DESIGN REVIEW COMMITTEE MEETING

4.I. 3637 Elm Street Addition

4.II. 3558-3668 Elm Street New Multi-Family Construction

DEPARTMENT OF PLANNING AND ZONING
PLANNER'S REPORT

SITE PLAN

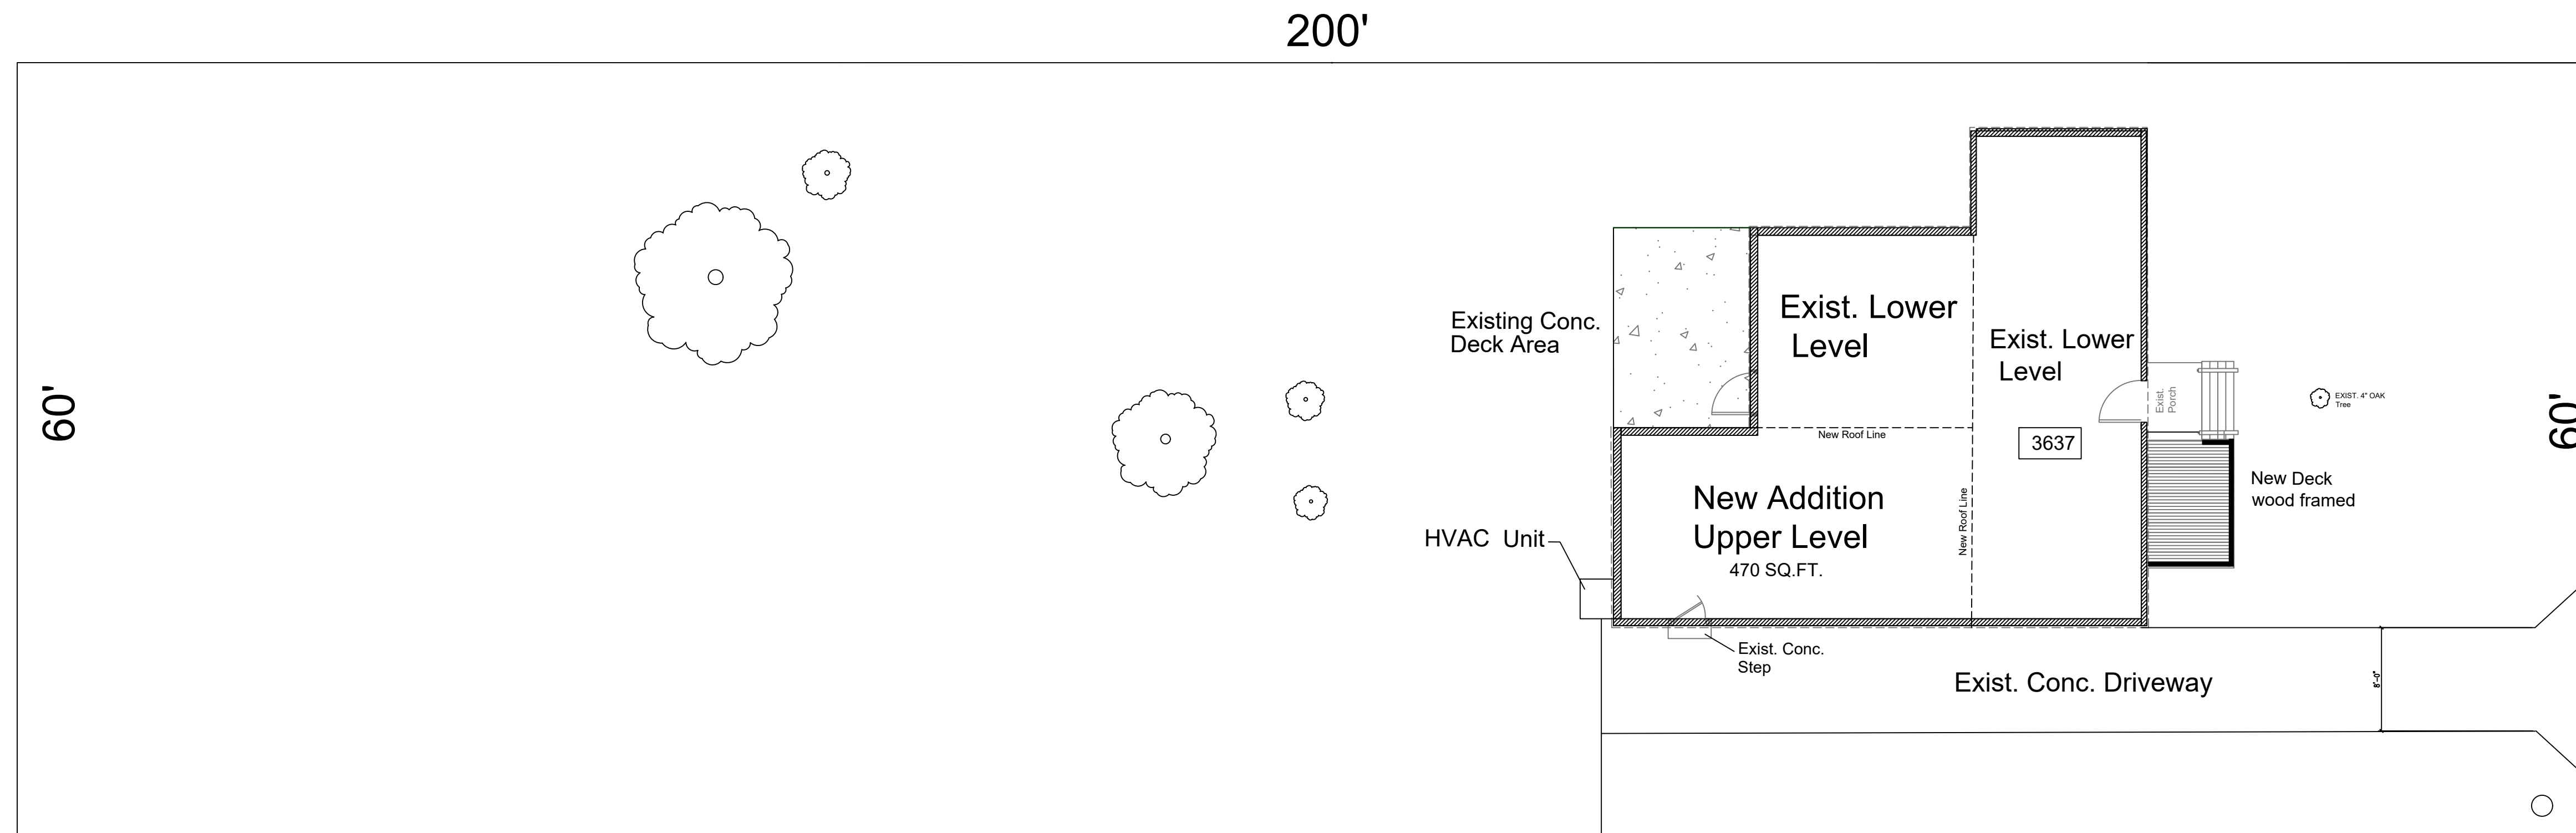
STAFF COMMENT: Required and actual setbacks should be provided on the site plan.

STAFF COMMENT: Landscape plan is not shown. One tree every 50' of road frontage (2 trees required) should be provided. See Tree Ordinance for acceptable trees. No fence is shown, should a fence be added, it must meet requirements.

STAFF COMMENT: An 8' driveway is shown on the site plan. Should the driveway be improved, it should meet the minimum 9' standard.

PROPOSED FLOOR PLAN - LOWER LEVEL

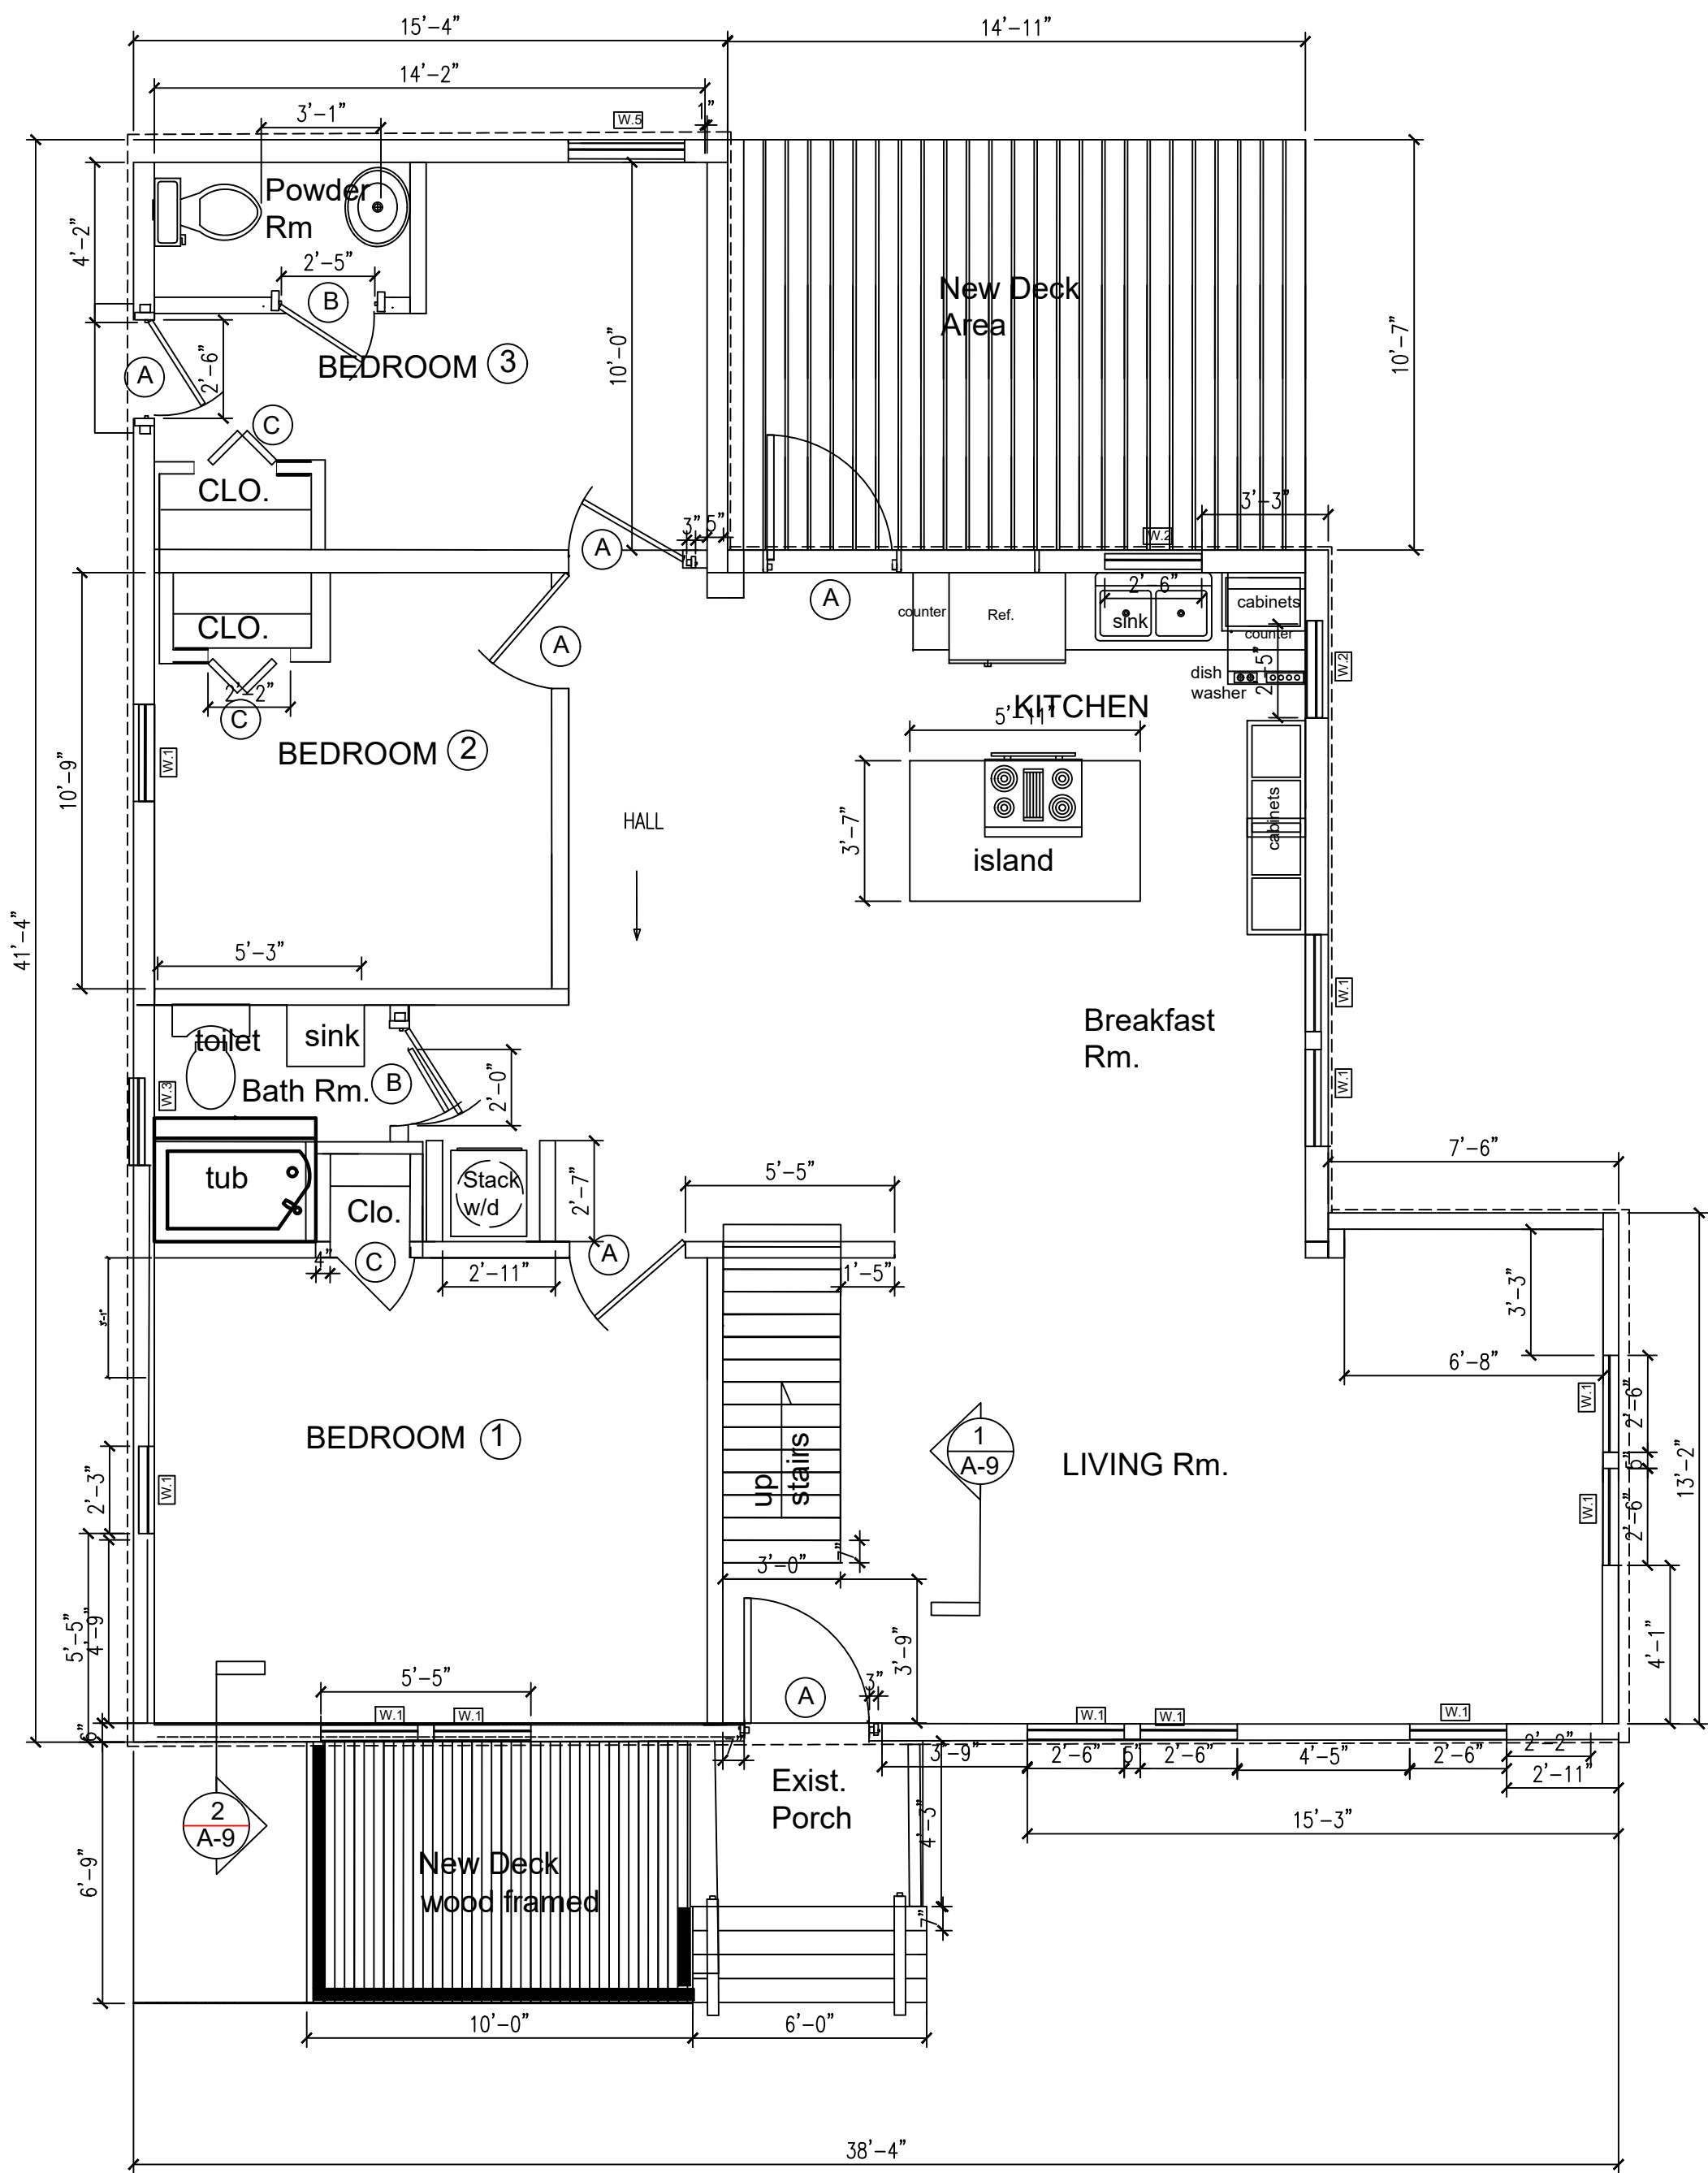
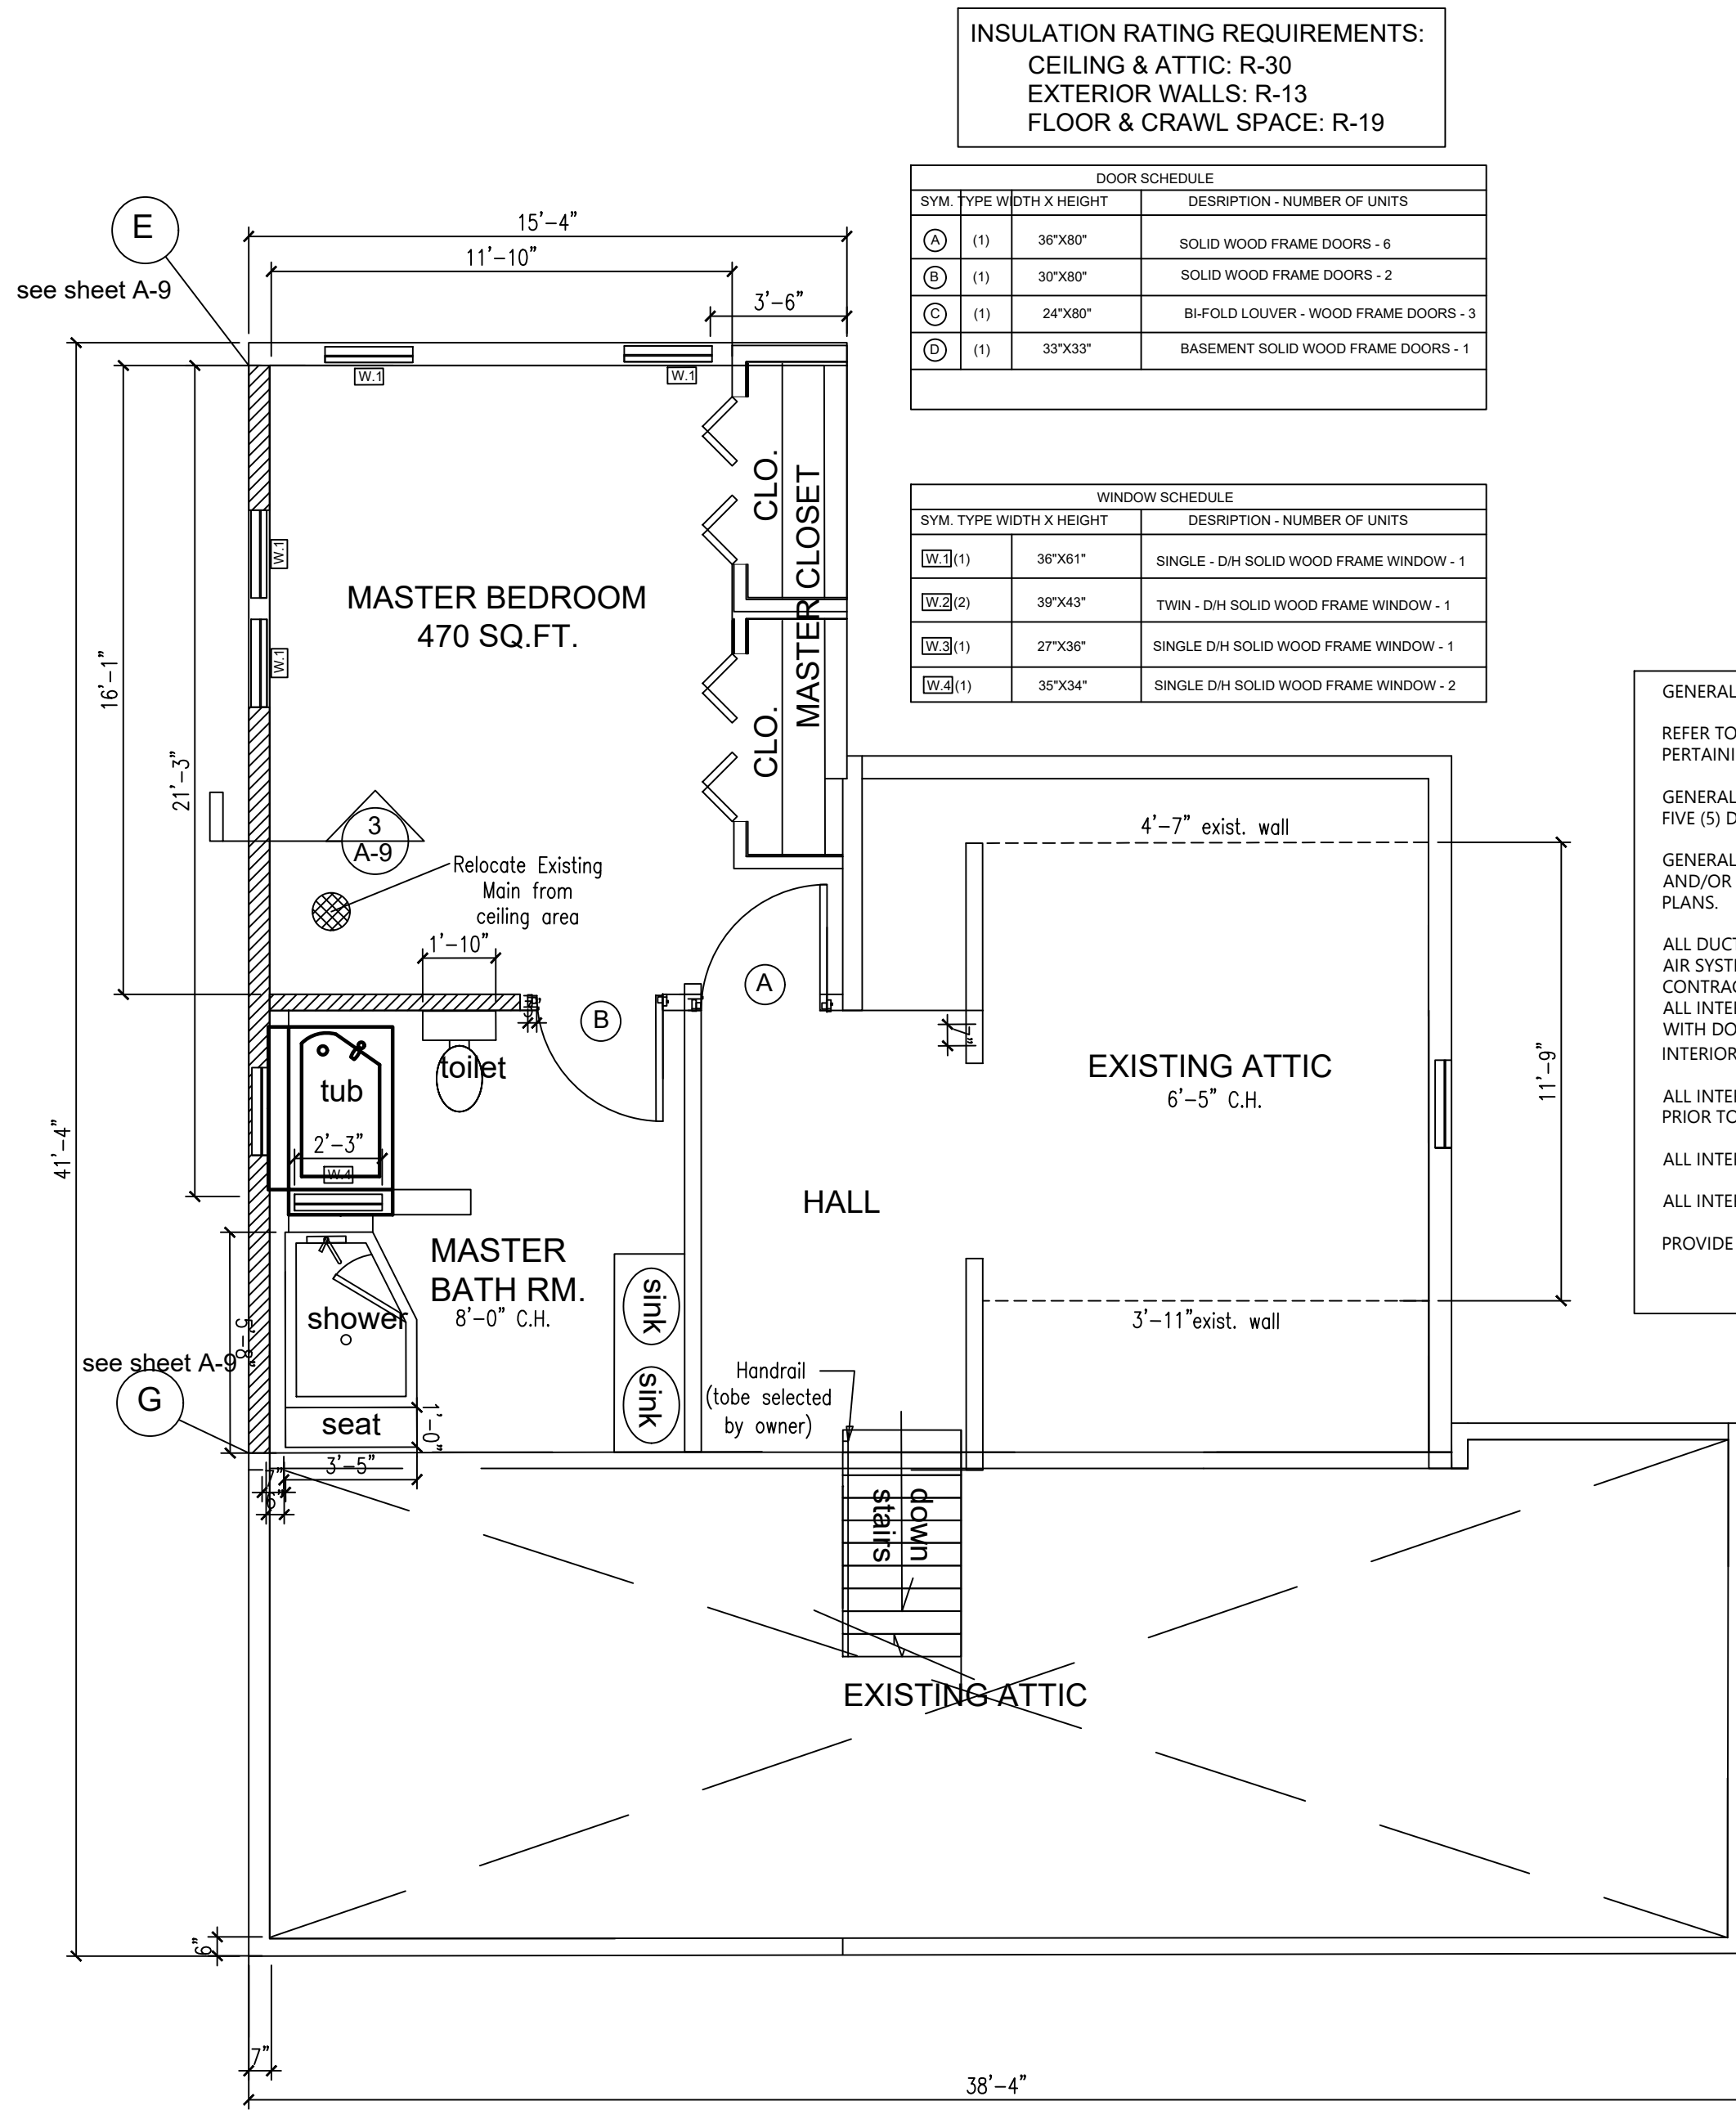
The new deck will not be added
